MANDATORY REFERRAL NO. 2024019 – EAST SILVER SPRING NEIGHBORHOOD GREENWAY

This is a Mandatory Referral review for the Montgomery County Department of Transportation proposal to create a neighborhood greenway on multiple streets adjacent to Downtown Silver Spring: Woodbury Avenue, Sligo Avenue, Grove Street, Bonifant Street, Cedar Street, and Houston Street.

No. MR2024019

Figure 3: Traffic Circle on Woodbury Drive and Bike/Pedestrian Connection to Fenton Street

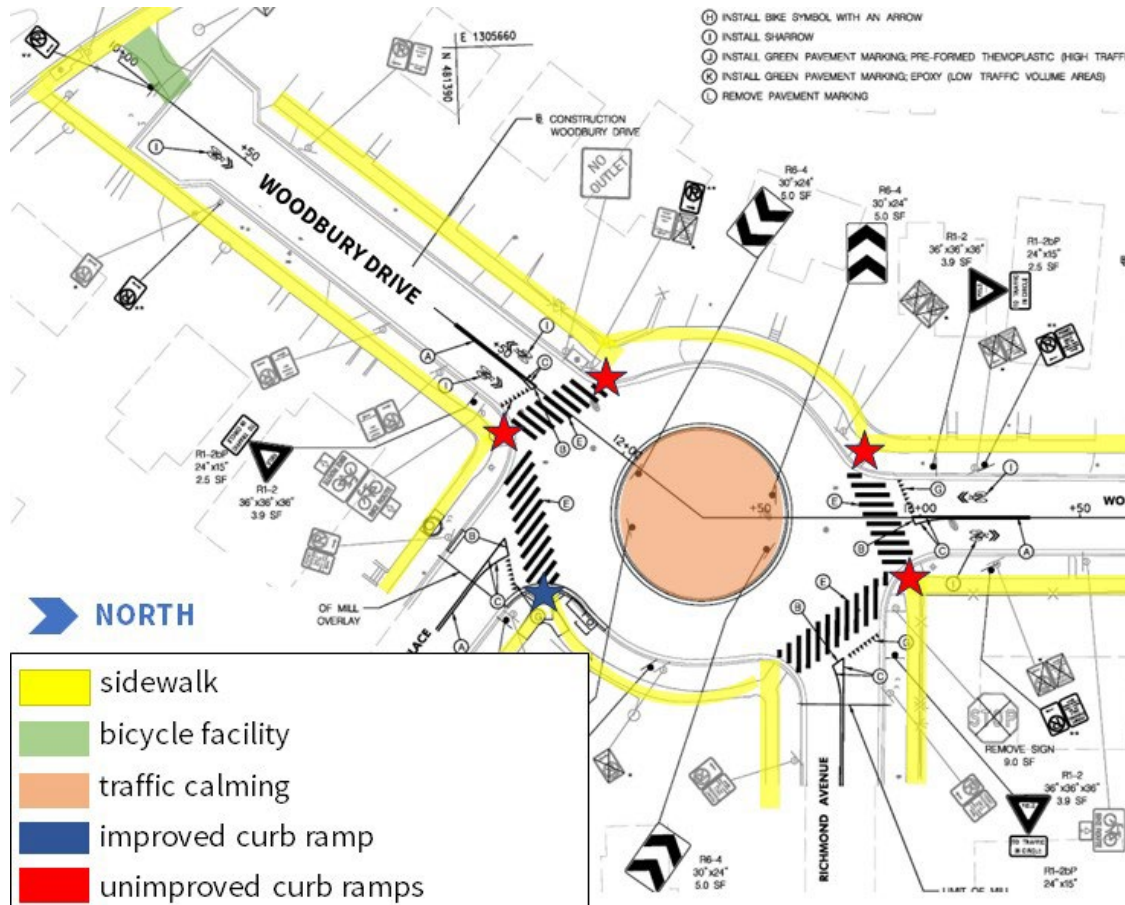
1. **Construct directional curb ramps with detectable warning surfaces at the traffic circle intersection of Woodbury Drive, Violet Place, and Richmond Avenue.** The project will upgrade one curb ramp (shown with a blue star in Figure 3), but other curb ramps remain untouched or misaligned, shown with red stars in Figure 3.

Figure 4: Traffic Circle Intersection of Woodbury Drive and Gist Avenue with Recommended Traffic Calming

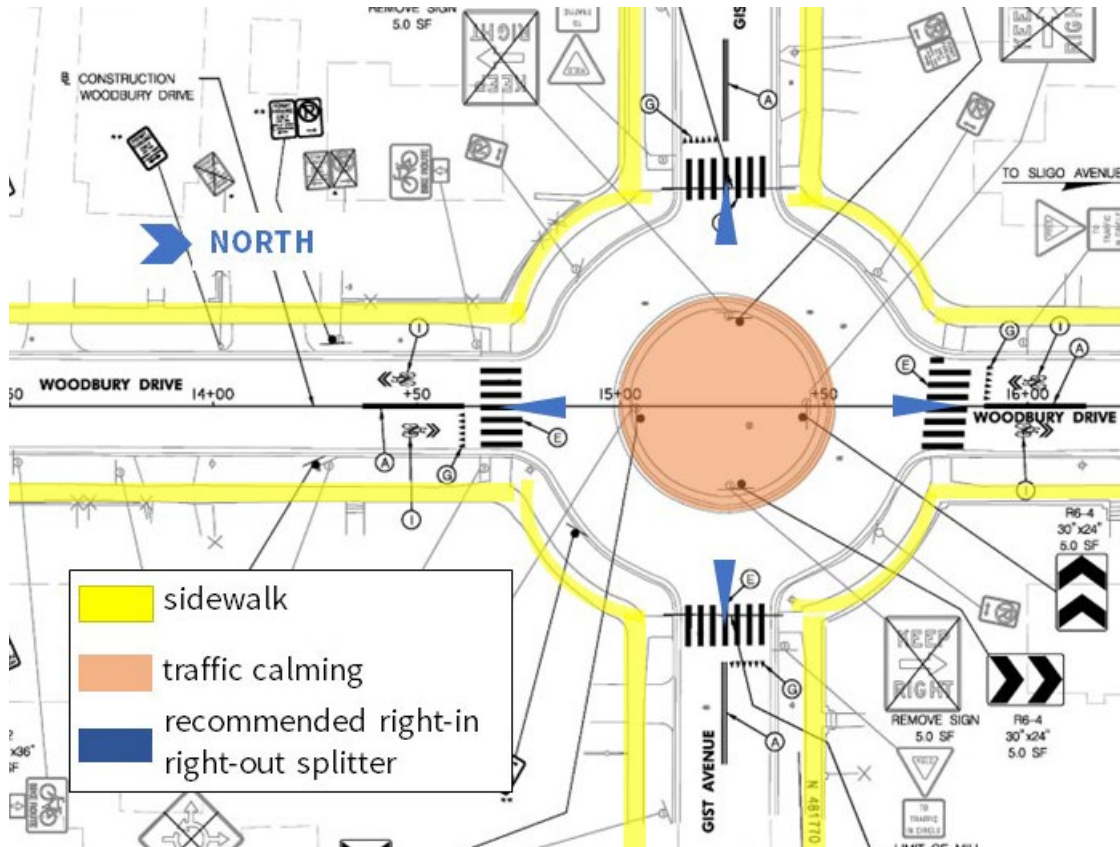
2. **Construct right-in right-out splitters at all entrances to the traffic circle intersection of Woodbury Avenue and Gist Avenue to control traffic speeds and direction.** The applicant is not proposing any changes to this traffic circle. The existing travel lanes are 20-foot-wide, and it is possible for vehicles coming from Fenton Street on Gist Avenue to enter the traffic circle in the wrong direction to turn north onto Woodbury Drive. Right-in right-out splitters, shown in Figure 4

in blue, would provide traffic calming and force vehicles to use the traffic circle in the proper direction.

Figure 5: Sligo Avenue with Shared-Use Path and Intersection Treatments

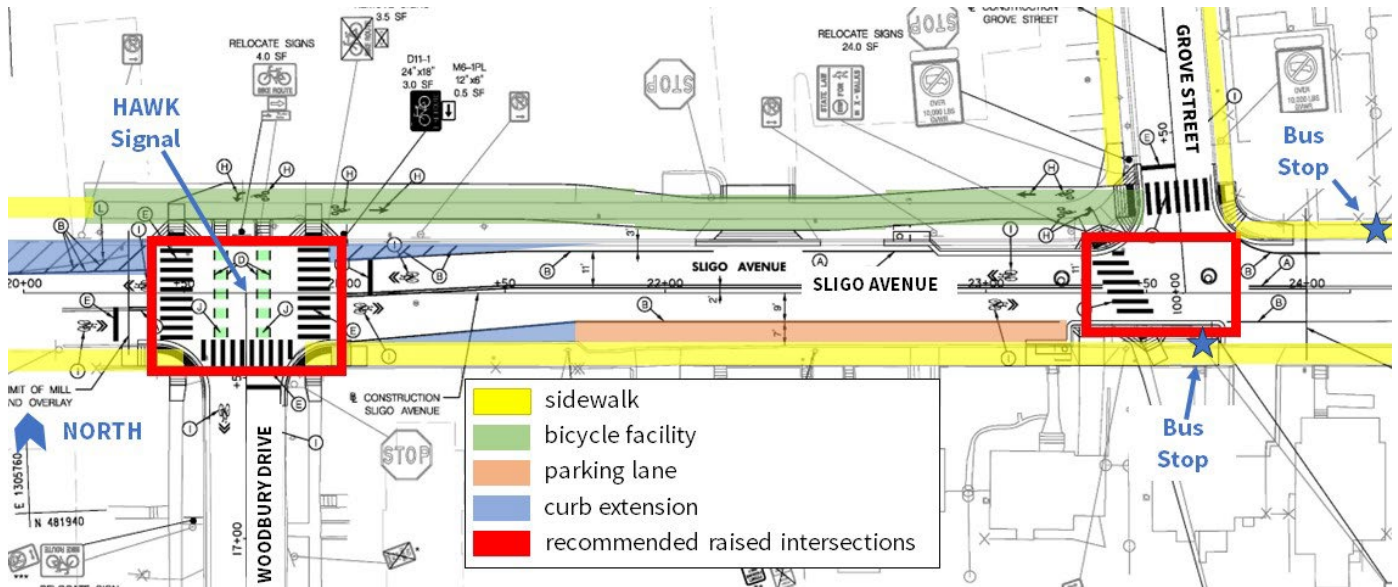
- 3. Construct raised intersections at Sligo Avenue and Grove Street and Sligo Avenue and Woodbury Drive to prioritize pedestrian and bicyclist crossings.** The applicant does not include any proposed changes to the Sligo Avenue and Grove Street intersection, which currently has a high visibility crosswalk but lacks traffic control (traffic signals or stop signs). This crossing is the most direct place for transit riders to access the bus stops at this intersection, and it would benefit from additional traffic control. The applicant proposes to improve pedestrian and bicycle crossings of Sligo Avenue at Woodbury Drive by installing crosswalks, stop bars, and a HAWK signal, while narrowing the travel lane by striping excess pavement on Sligo Avenue, as shown in Figure 5.

To reduce vehicle speeds and improve safety—especially at the Grove Street intersection—construct raised intersections, shown as red outlines in Figure 5. Raised intersections would also

act as beneficial gateway treatments to slow vehicles as they enter downtown Silver Spring. This treatment will create additional stormwater issues to be addressed.

Figure 7: Section of Grove Street with Roadway Narrowing and Stop-Controlled Intersection

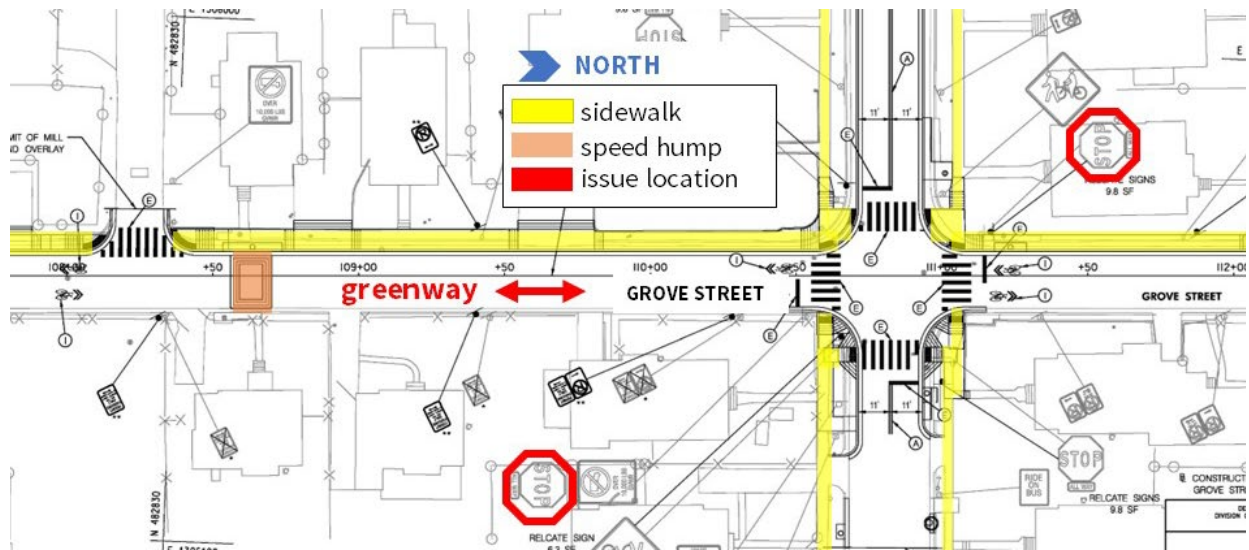
- 4. Remove stop control along the neighborhood greenway corridor while providing traffic calming treatments to prioritize bike traffic.** One neighborhood greenway design feature is to minimize the need for bicyclists to come to a full stop, as accelerating from frequent stops is strenuous—especially on hills.⁵ Per the *Bicycle Master Plan* (2018), “At two-way, stop-controlled intersections, [provide] priority assignment that favors the neighborhood greenway, so bicyclists can ride with few interruptions” (page 63). Since the proposed project includes speed humps (shown in Figure 6 in orange) and roadway narrowing (shown in Figure 7 in orange), the project team should consider removing some stop signs along Grove Street. MCDOT could continue monitoring traffic speeds after implementation to determine if additional treatments are needed to control traffic speeds. Additional traffic calming treatments could include not only more speed humps and roadway narrowing, but also chicanes or raised crosswalks.

Figure 8: Intersection of Bonifant, Grove, and Hankin with Sight Distance Issue

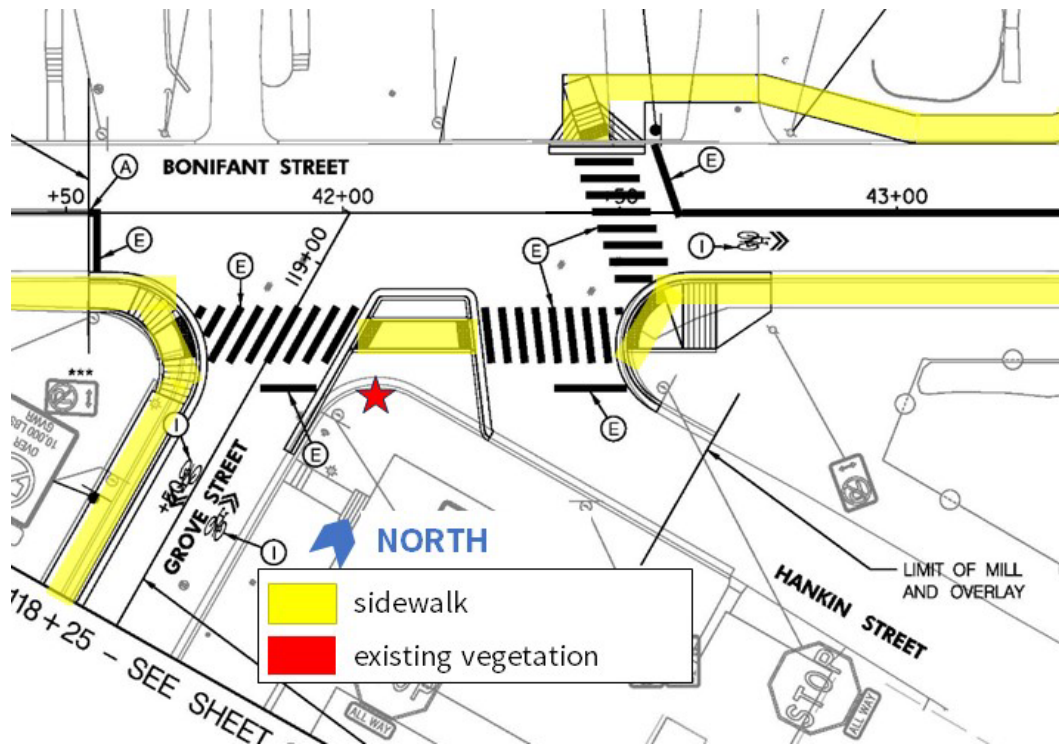
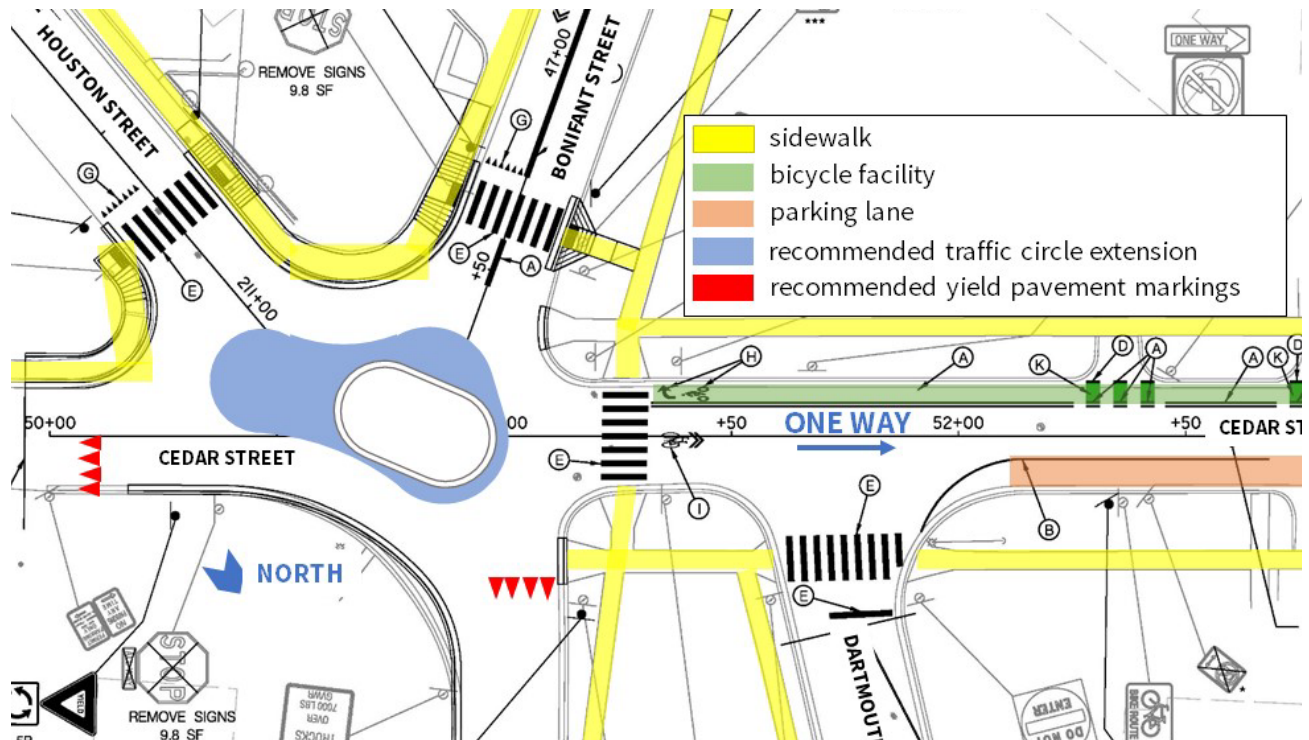
5. **Maintain clear sight distance at the intersection of Bonifant Street, Grove Street, and Hankin Street.** The applicant proposes to improve this intersection by installing a permanent curb extension (shown in blue in Figure 8) and realigning the stop bar on Grove Street. However, there is existing vegetation which could obstruct sight lines between motorists stopped at Grove Street and those stopped at Hankin Street (Figure 9). Maintain clear sight distance at all intersection approach legs.

Figure 11: Dartmouth Avenue and Cedar Street Intersection with Recommended Treatments

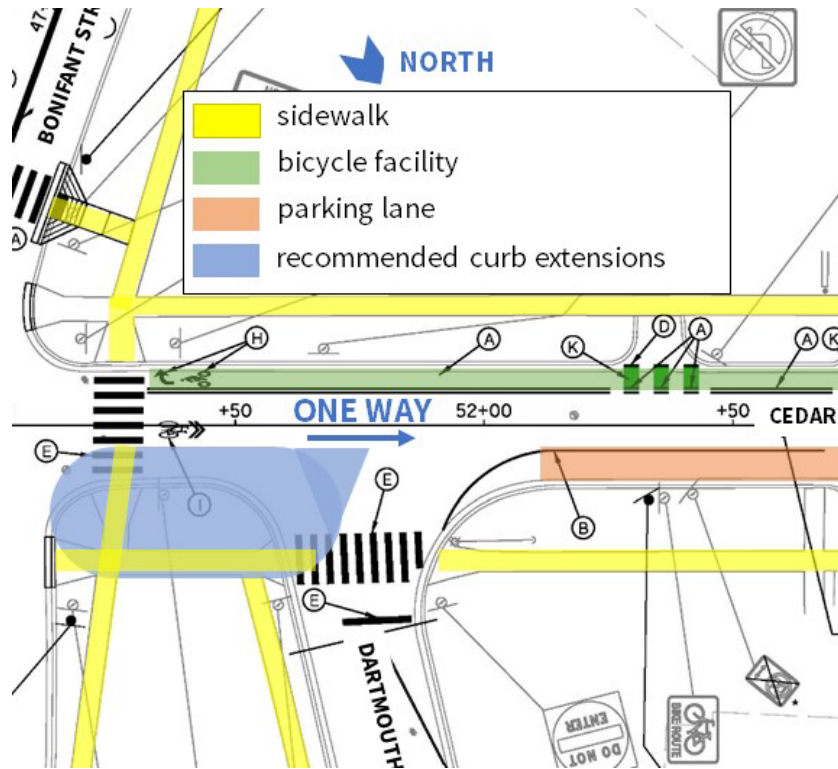
7. **Construct a curb extension and a right-out-only exit at the intersection of Dartmouth Avenue and Cedar Street** (Figure 11). This will reduce the vehicle lane width and ensure that vehicles can turn only right, in the direction of one-way traffic on Cedar Street.

Figure 12: Mountable Truck Apron Curb Radius (Photo: ODOT)

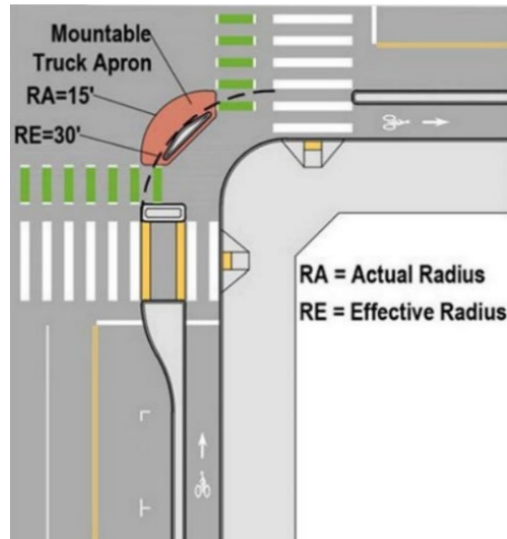
8. **Tighten curb radii to 15 feet and provide directional curb ramps at all intersections as described in the 2024 Complete Streets Design Guide.** Concerning curb ramps, the *Guide* states that “the preferred standard is two perpendicular curb ramps per corner, each aligning with desired paths of travel.” Guidance for turning radii includes that “designers should assume a maximum 10 miles per hour turning speed for passenger cars and a 5 miles per hour for all other vehicles.” Where wider turning radii may be helpful for larger vehicles or emergency operations, consider the use of mountable curbs or relocating the receiving leg stop bar to allow for encroachment, as shown in Figure 12.

Figure 13: Tighter Curb Radii Visibility Illustration

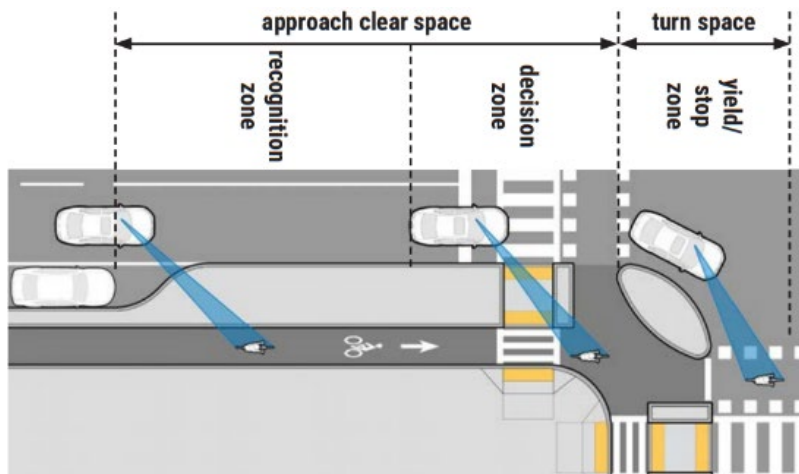
Providing tight turning radii is essential to reducing the turning speed of motor vehicles, improving visibility among motorists, pedestrians, and bicyclists, and reducing the likelihood and severity of collisions between roadway users. Figure 13 illustrates how tighter turning radii improve visibility by allowing motorists to cross bikeways, sidewalks, and sidepaths at a perpendicular angle so potential conflicts can be seen through the front windshield, not over a shoulder. Additionally, smaller curb radii shorten pedestrian street crossings, reducing their exposure to conflict, and make it easier to provide directional curb ramps to better guide pedestrians in the crosswalk through an intersection. Where wider turning radii may be helpful for larger vehicles or emergency operations, consider the use of mountable curbs or relocating the receiving leg stop bar to allow for encroachment.

Figure 14: Location of Stormwater Erosion at Bullis Local Park

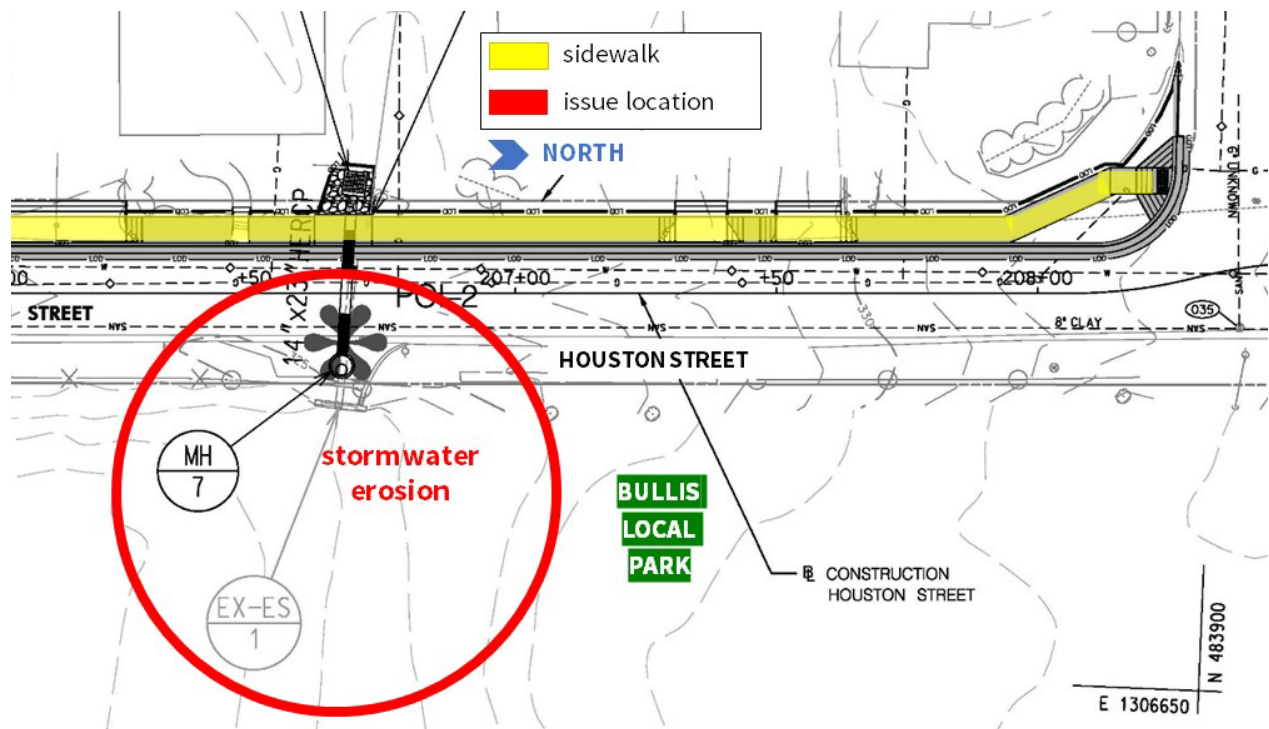
1. **Remove the existing asphalt apron in the shoulder of Houston Street (Station 206+45 to Station 206+75) (Figure 14) and provide stable conveyance of stormwater runoff into the outflow channel on parkland.** The existing apron is diverting stormwater runoff from Houston Street into Bullis Local Park and eroding the hillside down into the park (Figure 15). Replace proposed manhole (MH) 7 on Houston Street with a proposed inlet structure, remove existing asphalt in the shoulder behind EX-ES 1, and provide grass swales in shoulder (on both sides of inlet) that direct stormwater from Houston Street into the new inlet and protected outfall on parkland. Coordinate with Parks Staff regarding the appropriate design.
